STATE OF DELAWARE  
New Castle County Vocational Technical School District

SUBJECT: ADDENDUM TO REQUEST FOR PROPOSAL NO. 2:  
Renovations to the Howard High School of Technology – Bid Package 'P'

**ADDENDUM NO. 2**

**NEW CASTLE COUNTY VOCATIONAL TECHNICAL SCHOOL DISTRICT  
HOWARD HIGH SCHOOL OF TECHNOLOGY  
BID PACKAGE 'P'  
WILMINGTON, DELAWARE**

**PEDESTRIAN - VEHICULAR BRICK PAVING**

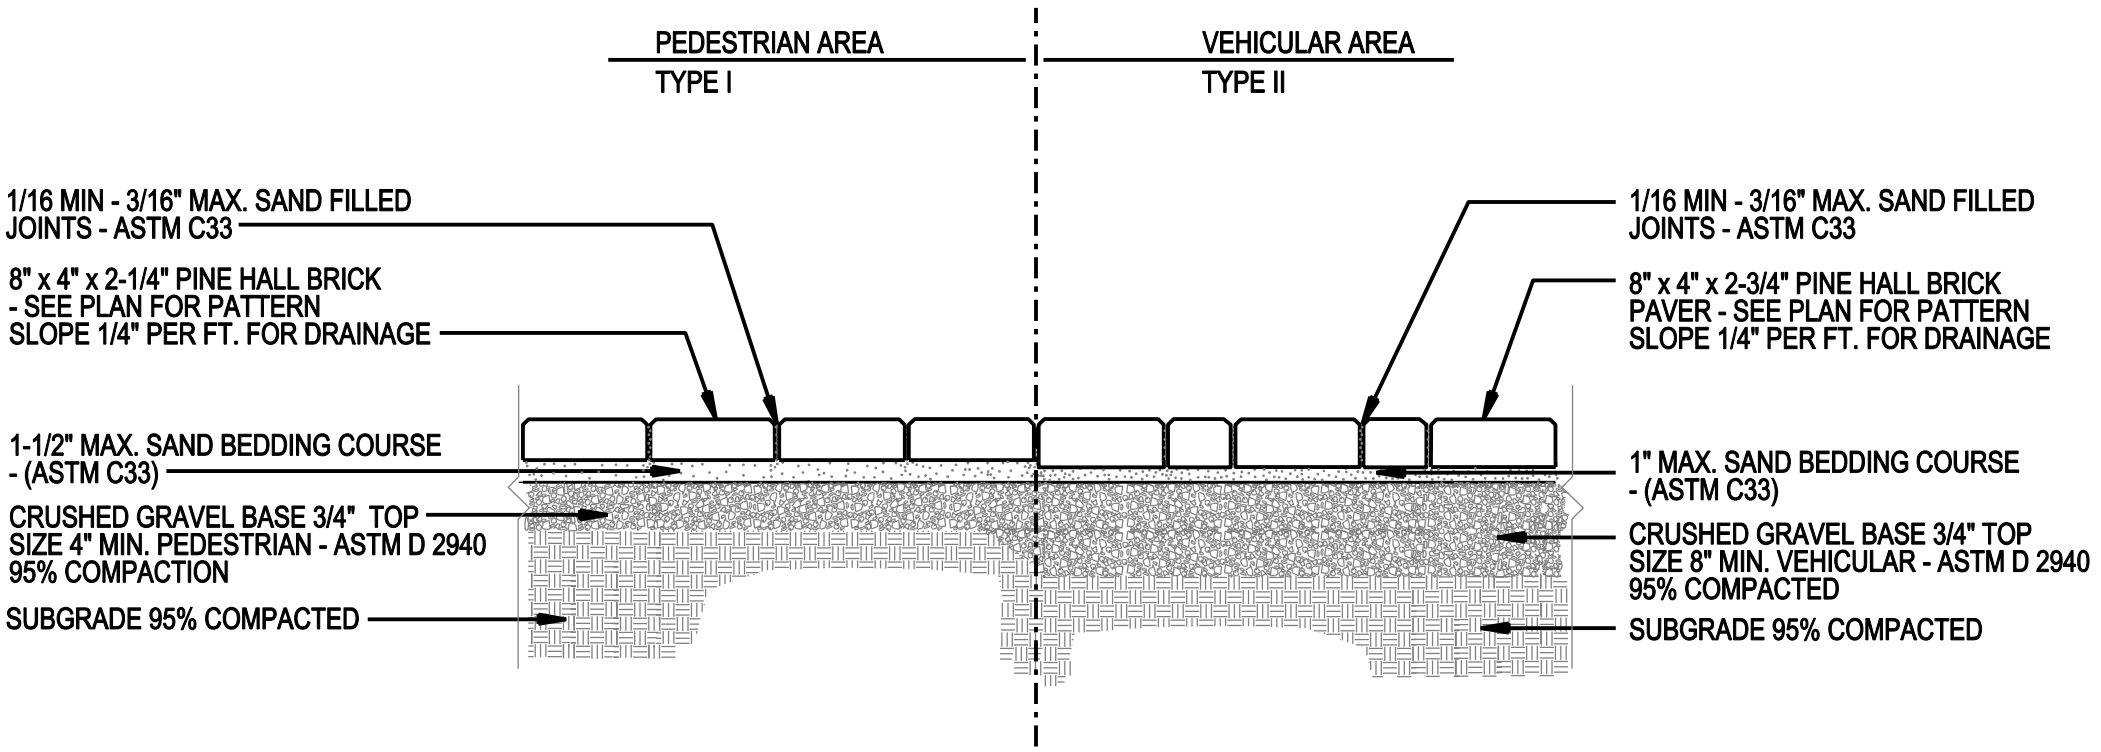
- a. Vehicular pavers are labeled "Type II" and the vehicular paver zones are defined by a heavy dashed line. Pedestrian pavers are labeled Type I. See attached plan.
- b. Detail 7/L2.4 shows the installation for both types. See attached revised detail.
- c. See specifications for Type I "Pedestrian" and Type II "Vehicular" paver sizes. Section 321416 2.03 & 2.04 respectively.
